April 23, 2020

**Reference: 245 Rideau Street – Proposed High-Rise Development  
Noise Control Study Addendum Letter:  
Revised Usage of Tower 'A' South from Hotel to Residential  
Our File No. 113195**

**Reference: 245 Rideau Street – Proposed High-Rise Development  
Noise Control Study Addendum Letter:  
Revised Noise Level Analysis and Attenuation Measures  
Our File No. 113195**

**H A100**

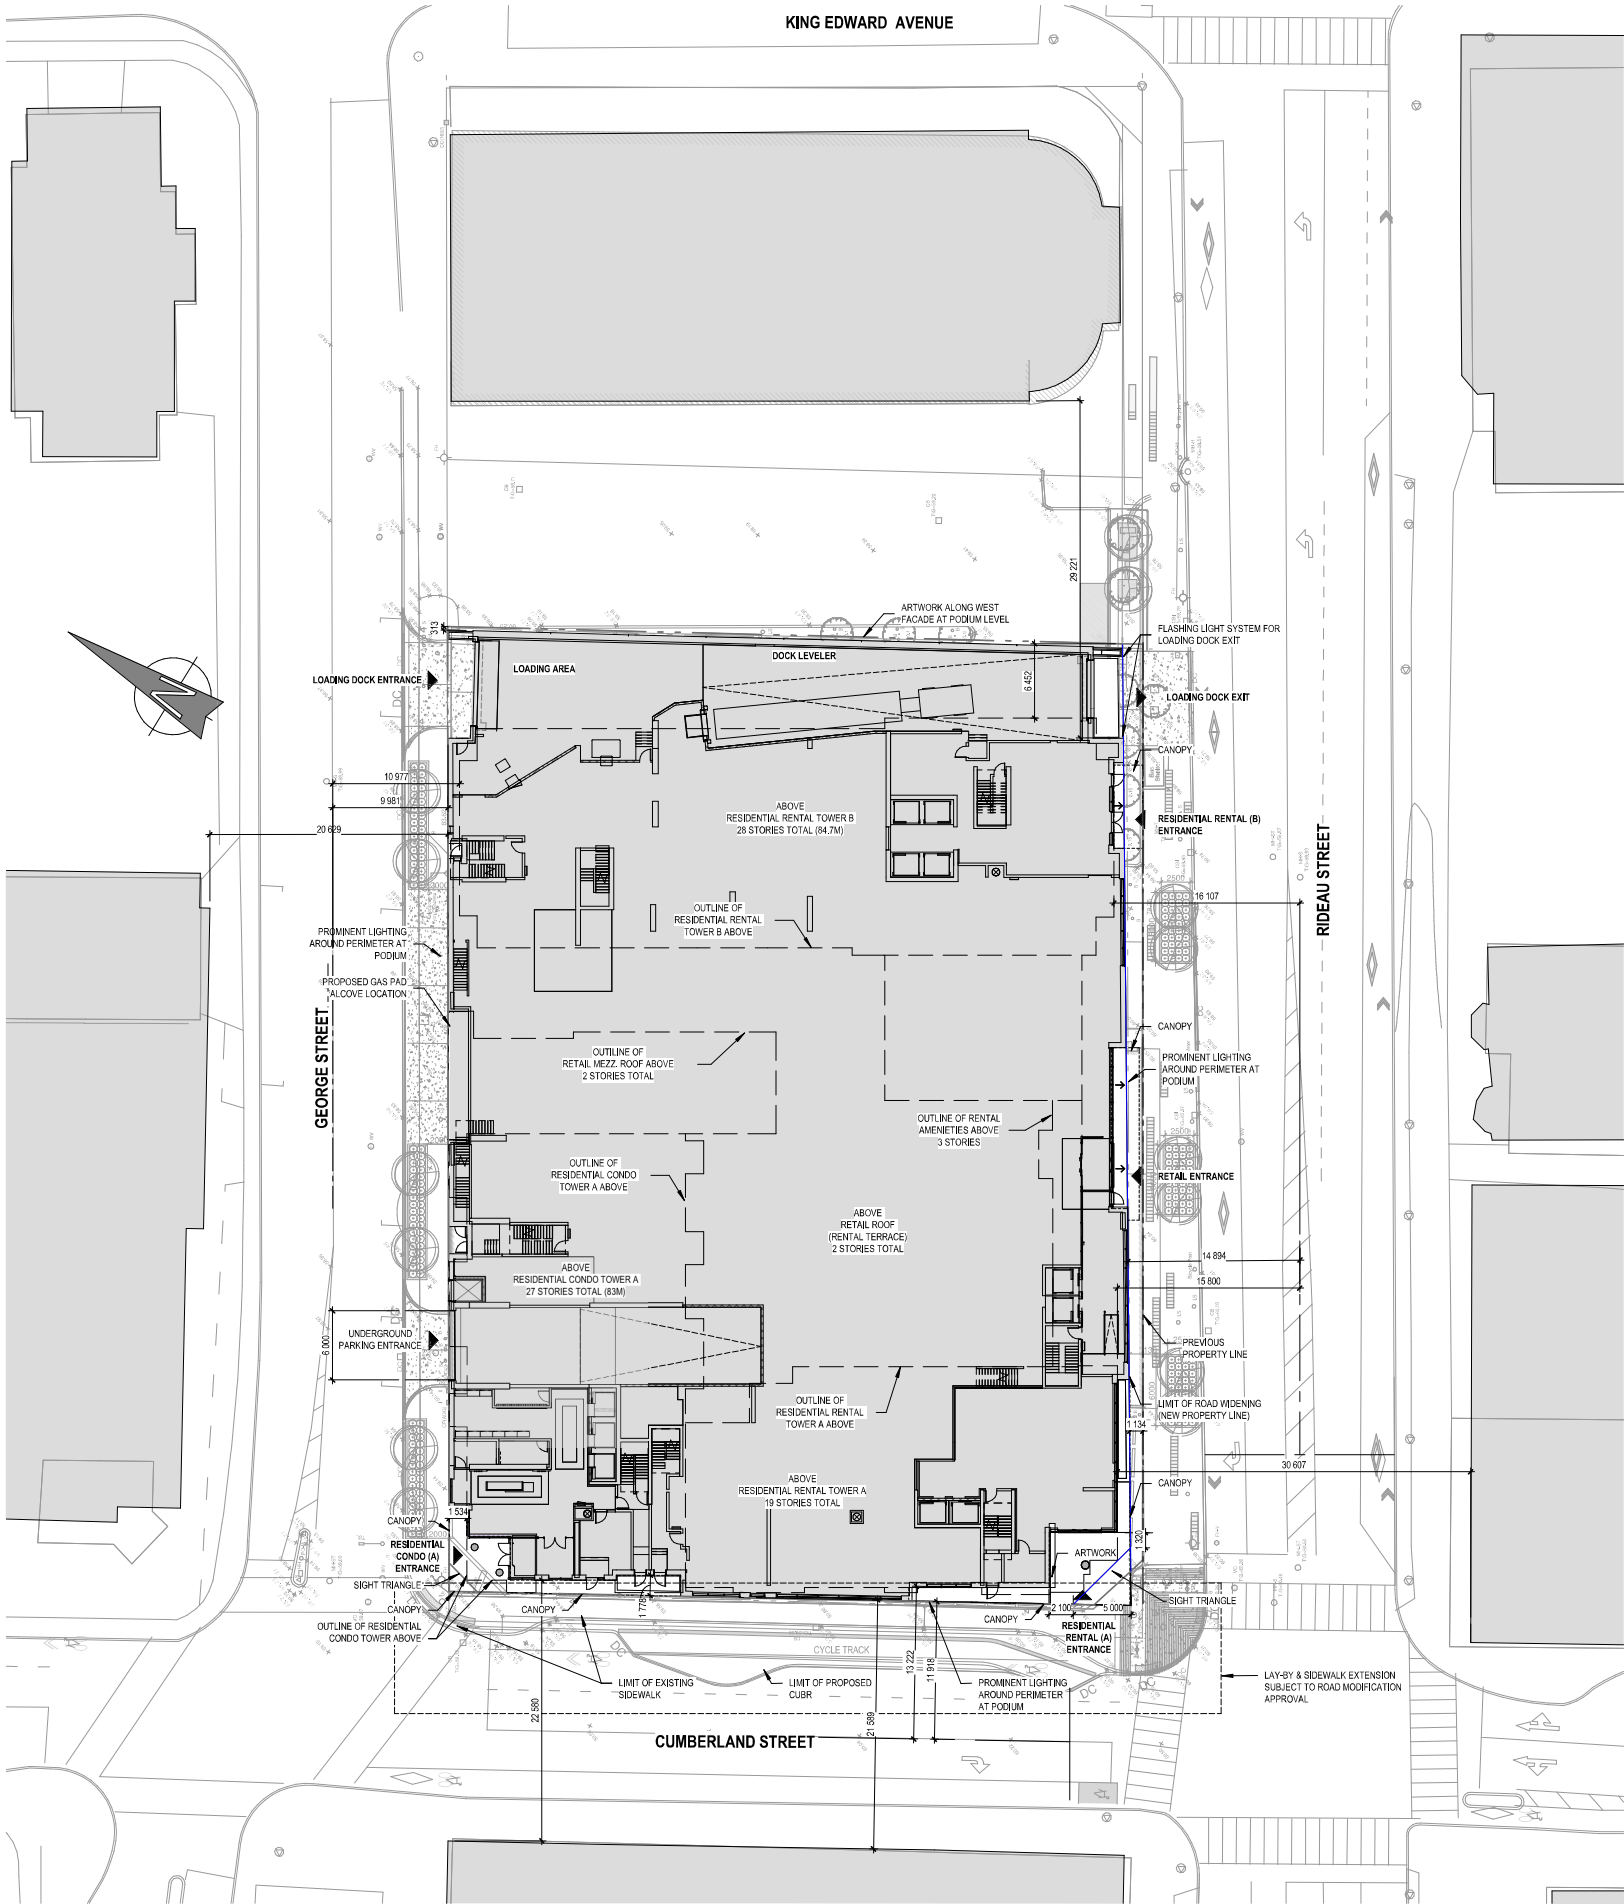
Subsequently, some further revisions have been made to the proposed development and site plan. The changes are summarised as follows. Refer to the attached revised Site Plan for details.

- The previously proposed hotel tower (Tower 'A' South) is now proposed to be a residential rental tower.
- The previous 2<sup>nd</sup> floor hotel amenity area has been removed and replaced by additional shared outdoor roof terrace patio area.
- A walkway connection between Tower 'A' South and Tower 'B' at the 2<sup>nd</sup> floor has been added.
- Minor changes to the floor plate shape of Tower 'A' South.
- No changes to the height of the towers, however a mezzanine level has been added to the commercial space in the podium. As a result, the podium is now considered two (2) storeys rather than one (1) storey so all towers are now considered one (1) storey taller than on the previous Site Plan.

These recent site plan revisions do not result in any changes to the noise level analysis, noise attenuation measures or notice requirements to be placed on title for units previously presented in the addendum letter dated March 19, 2020. The same residential sound level criteria was applied to the previously proposed hotel rooms.

RECEPTOR LOCATION PLAN

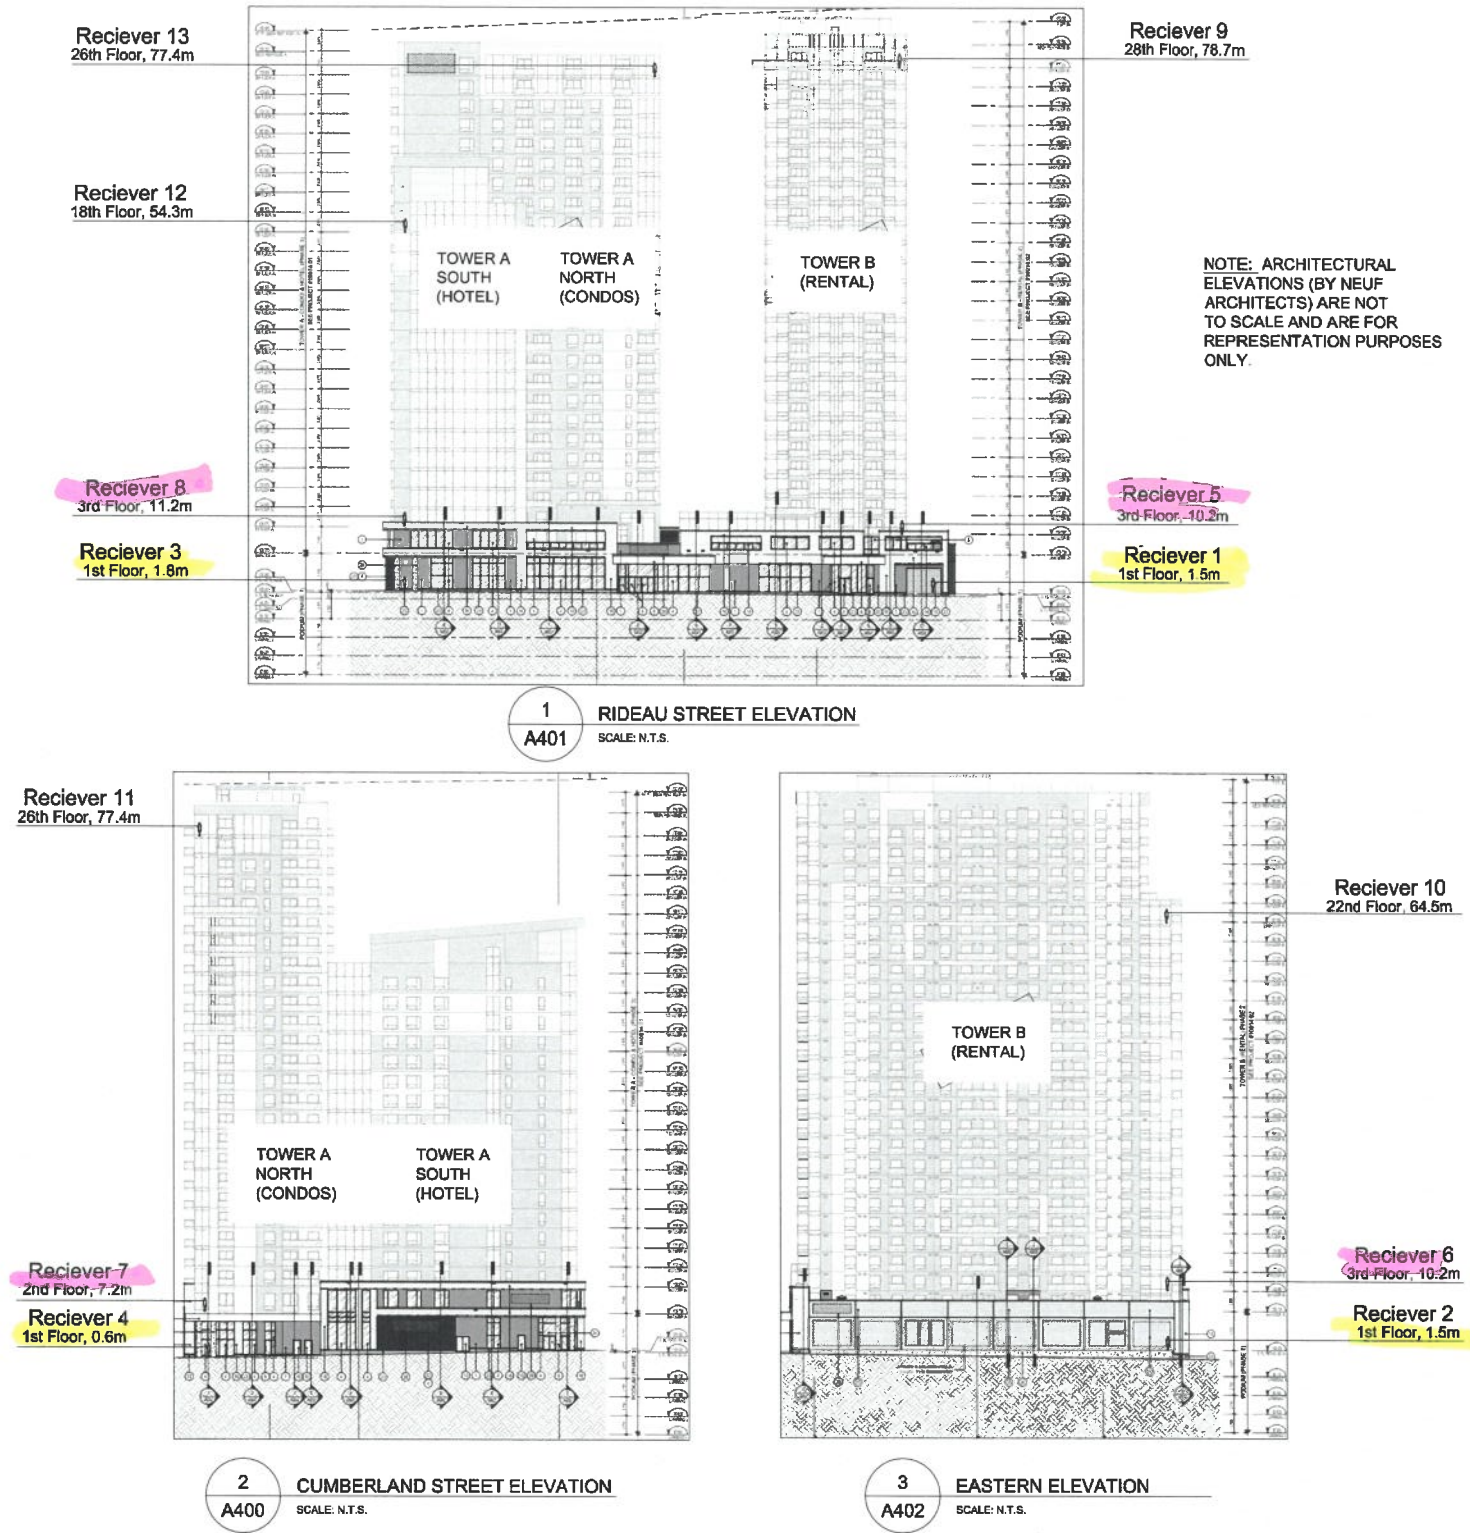
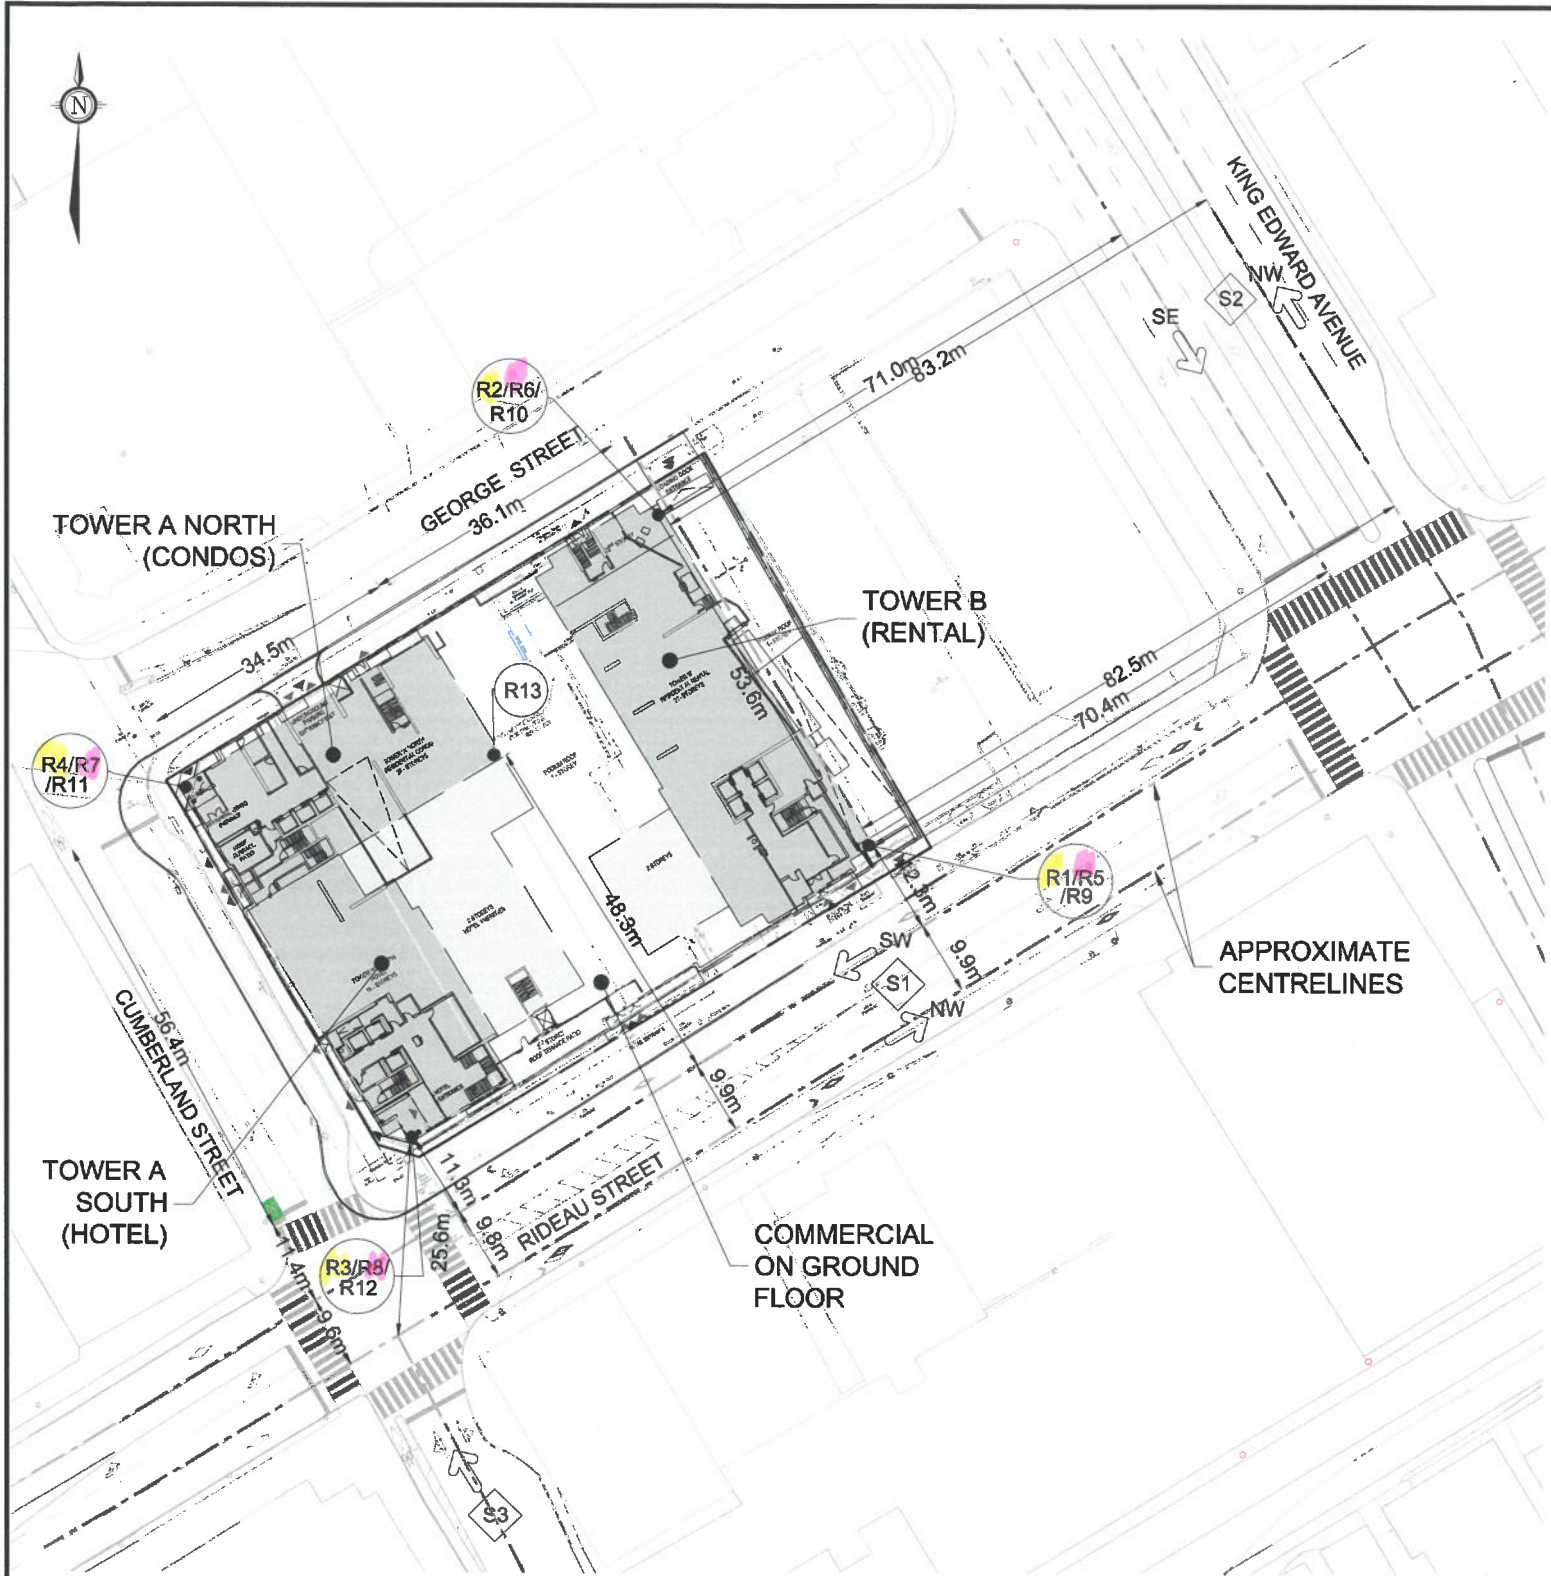
Predicted noise levels were modelled using the STAMSON computer program, Version 5.03, issued by the MOE. Receptor locations used in the noise simulations are shown on the attached figure (**Figure 3 – Receptor Location Plan**). Sources located greater than 100m from a receptor were omitted in the simulation for that specific receptor.
